The Proposed Karreebosch Wind Farm and associated infrastructure, Northern and Western Cape Provinces

Motivation for amendment of Environmental
Authorisation

DEA Ref.: 14/12/16/3/3/2/807/AM2

October 2018

Figure 2.2: The authorised turbine layout (A3 Map included in **Appendix F**) – 65 turbine positions, with the exclusion of turbine 17 as per Condition 35 of the EA.

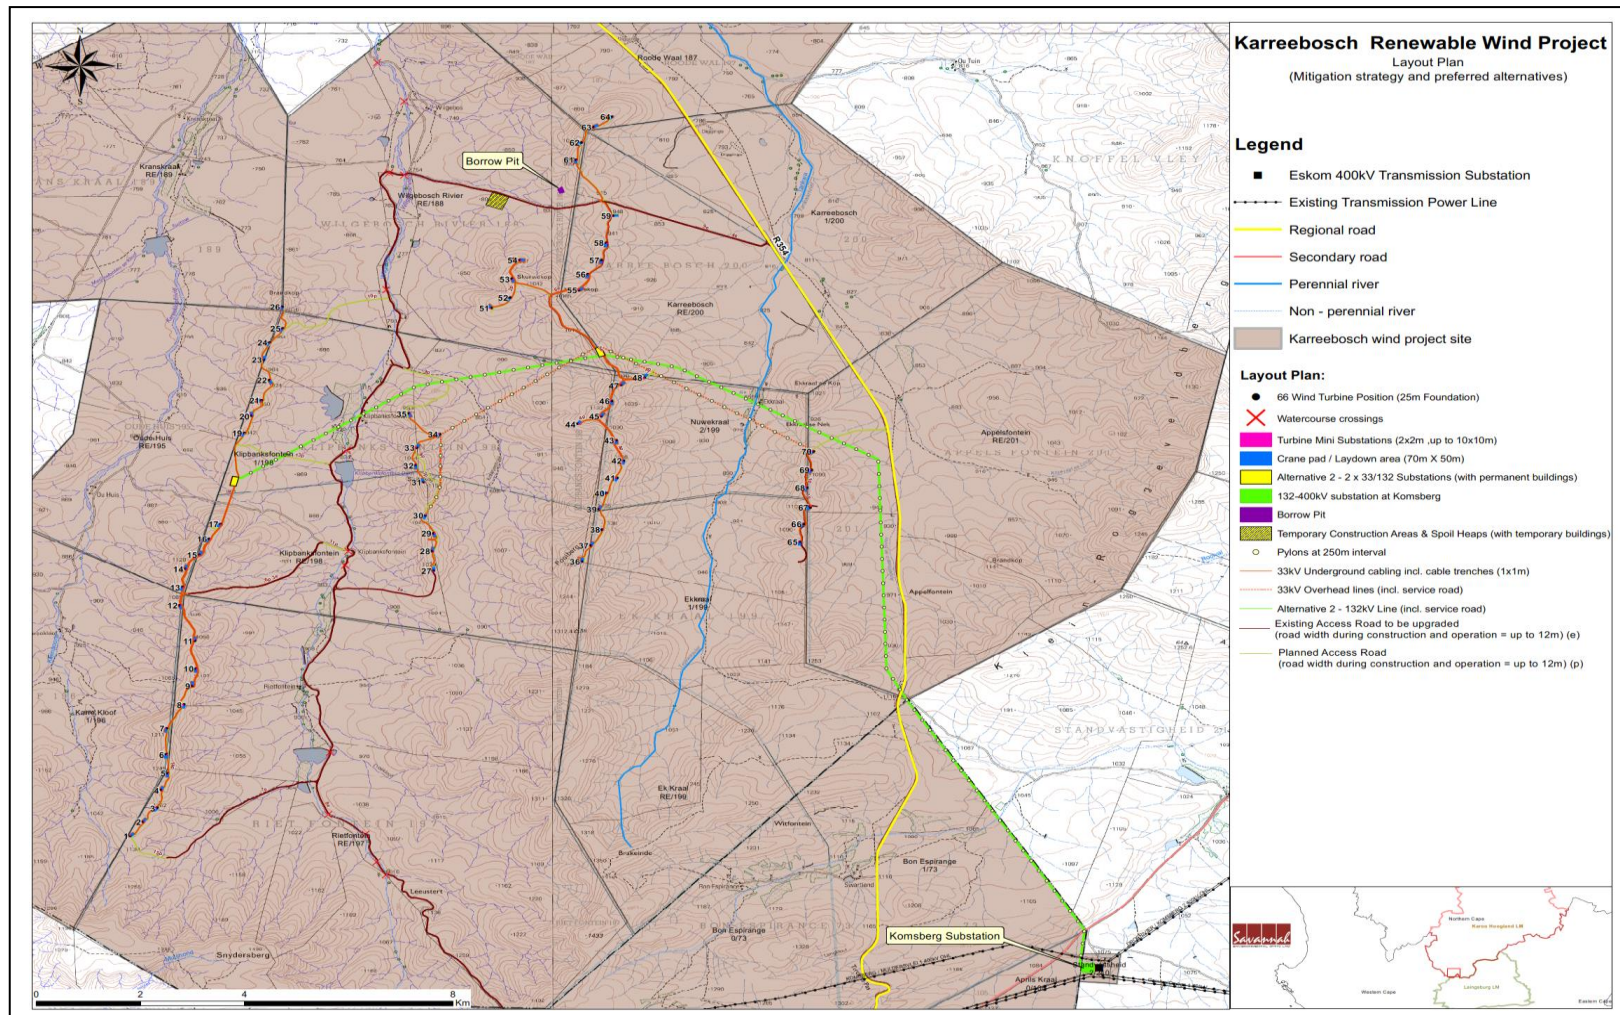
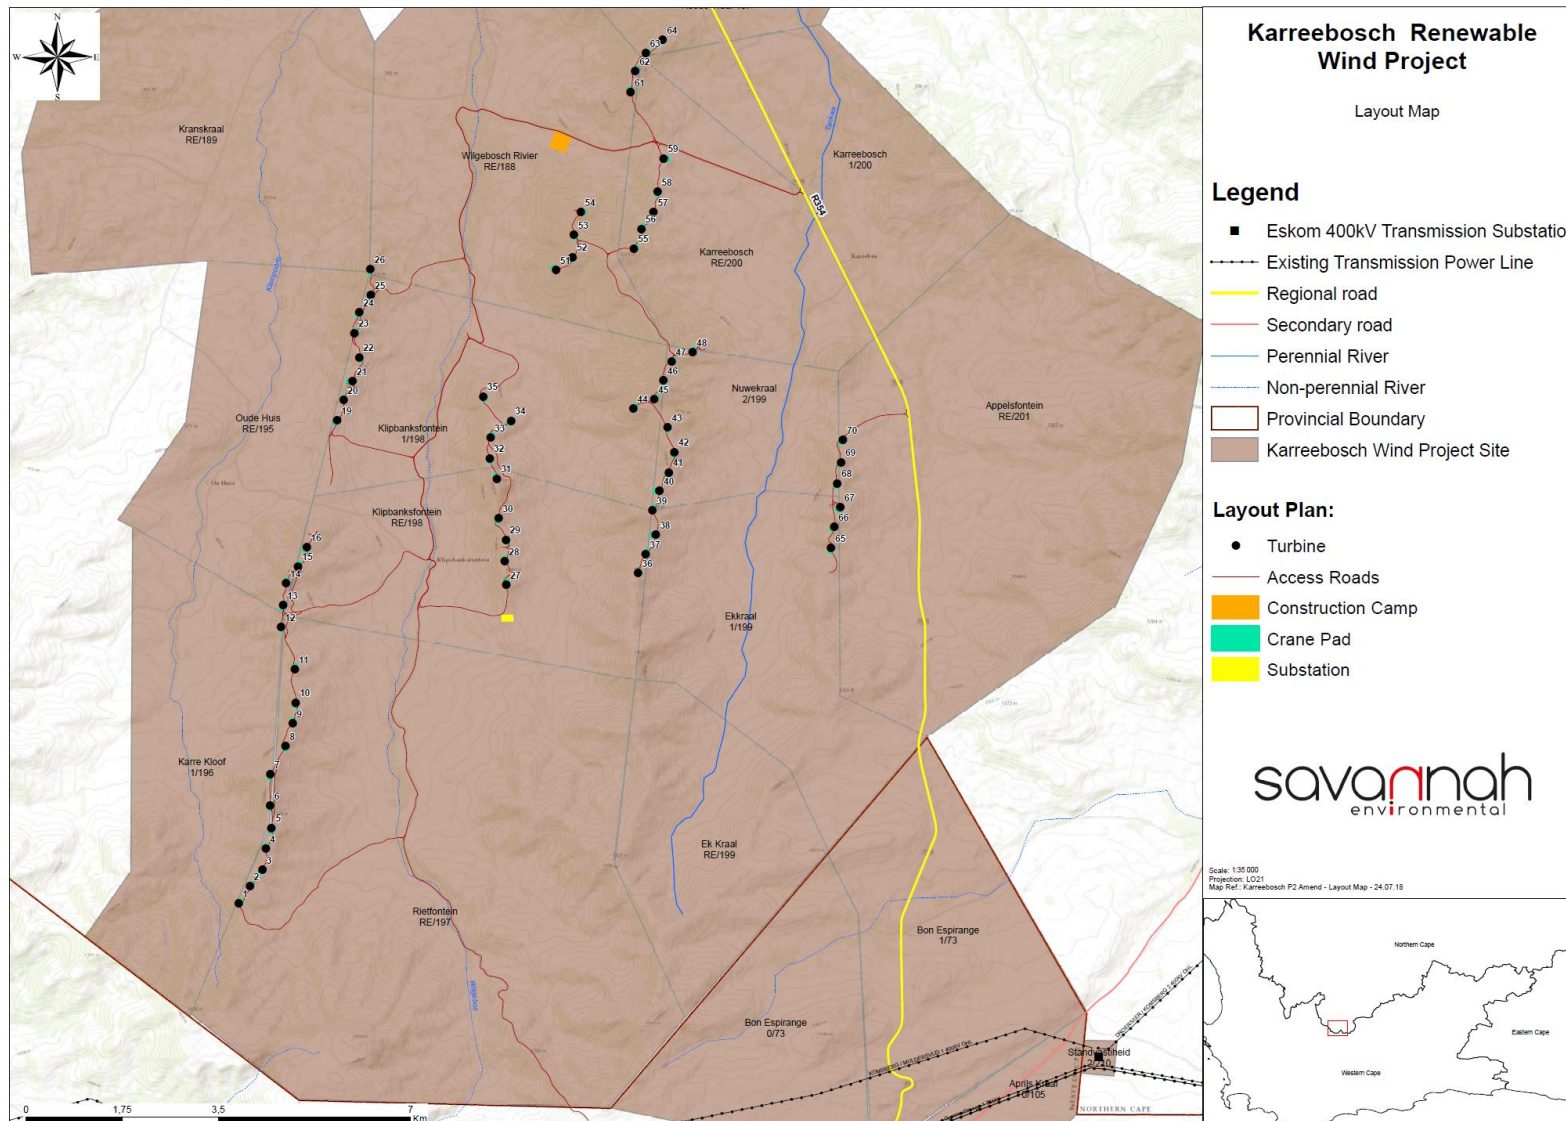
The approved positions of the proposed wind turbine layout consisting of the proposed 65 wind turbines will remain in the same locations as assessed and detailed in the EIA Report, and a diagram of this has been included in **Appendix F**.

² Following submission of the Final EIA Report dated September 2015, Condition 35 of the EA dated 29 January 2016 recommended removal of wind turbine 17 from the layout. This has been undertaken and is reflected in **Figure 2.2** below.

Figure 4.1: Viewshed analysis representing the potential total visual exposure of the original turbine dimensions (illustrated in green) compared to the proposed new turbine dimensions (illustrated in red).

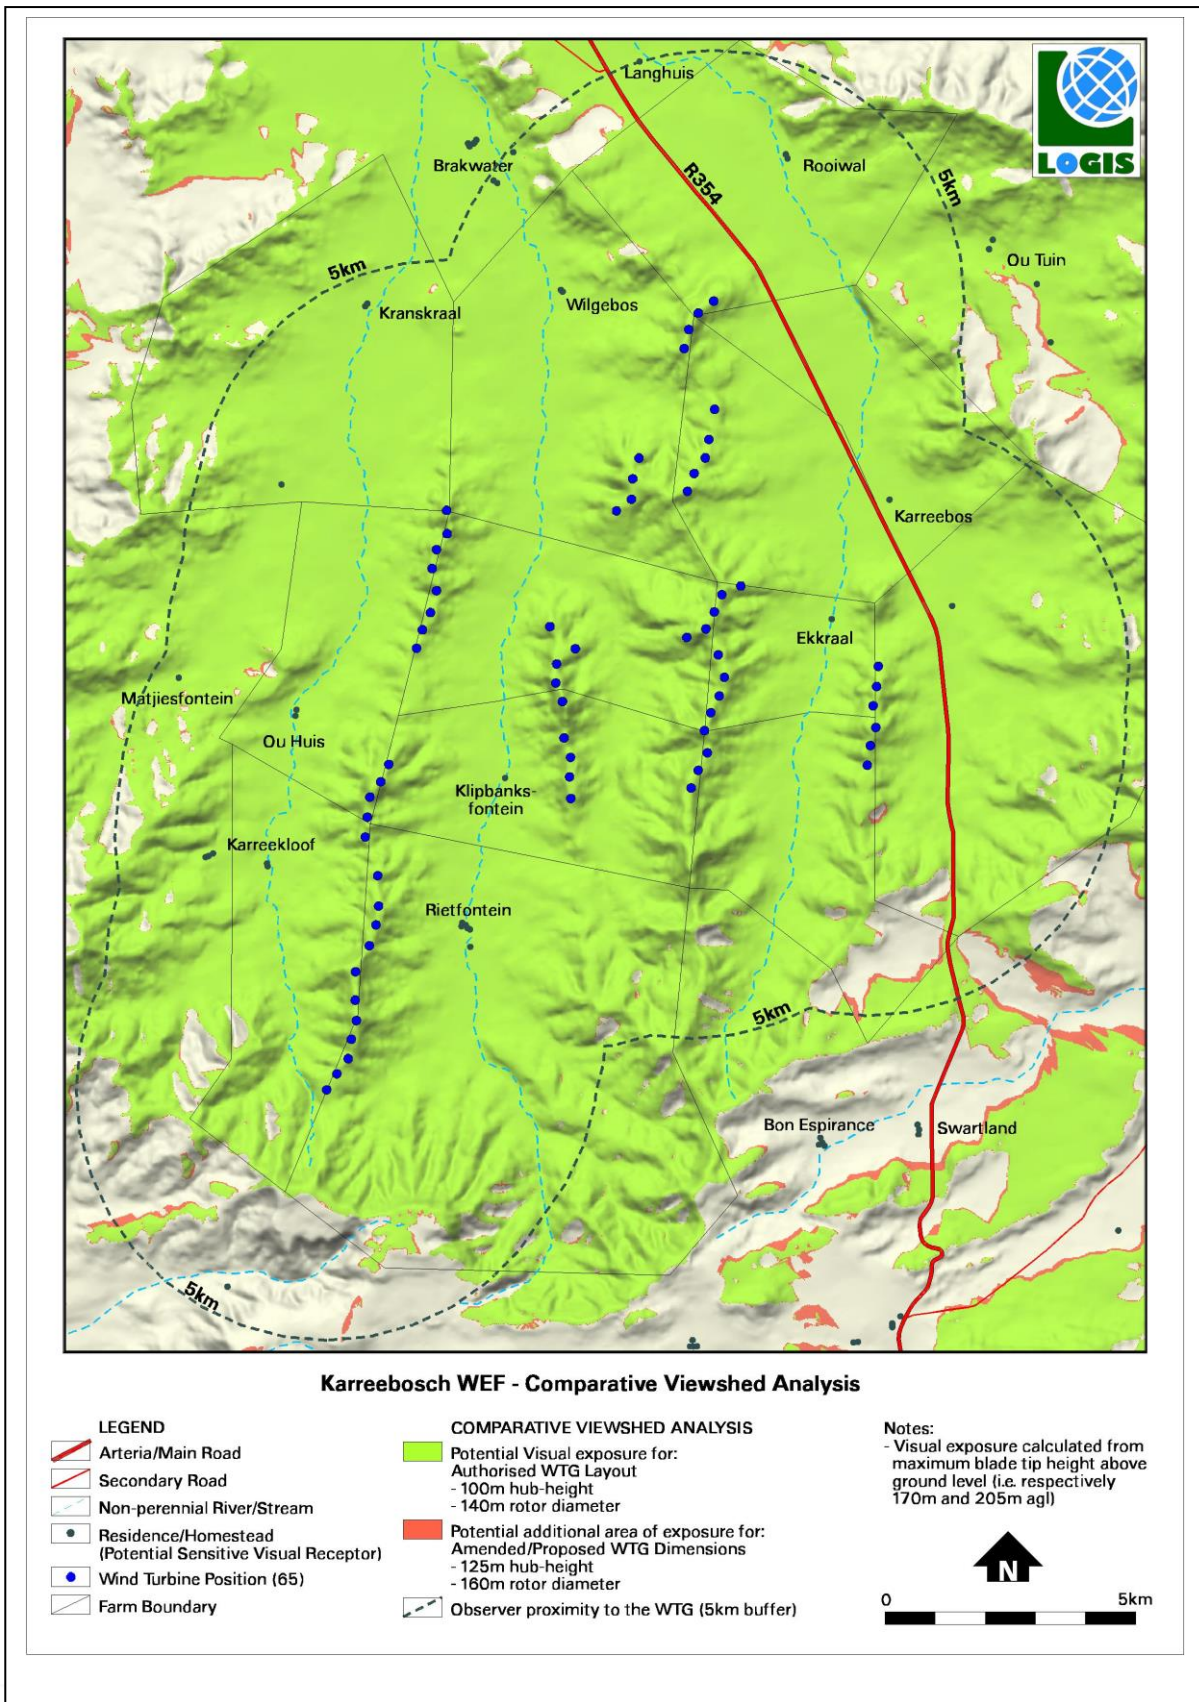
The visibility analysis was undertaken from each of the wind turbine positions (65 in total) at an offset of 170m (maximum blade tip height) above ground level. The result of this analysis represents the potential total visual exposure of the original turbine dimensions (indicated in green). The viewshed analysis was repeated at an offset of 205m to indicate the visual exposure of the increased turbine dimensions (shown in red). The results of the visibility analyses are displayed on **Figure 4.1**.

It is clear that the approximately 17% increase in turbine dimensions would have a relatively small influence on the overall visual exposure, due to the turbine structures previously approved and the elevated positions of the turbines on ridges. The surface area (within the study area) of the original turbine exposure is 435km², compared to the 443km² of the increased dimensions of the wind turbine exposure. This is an increase of 7km², or alternatively, **an increase of only 1.6% in potential visual exposure**. There are no additional sensitive visual receptors located within the area of increased visual exposure.
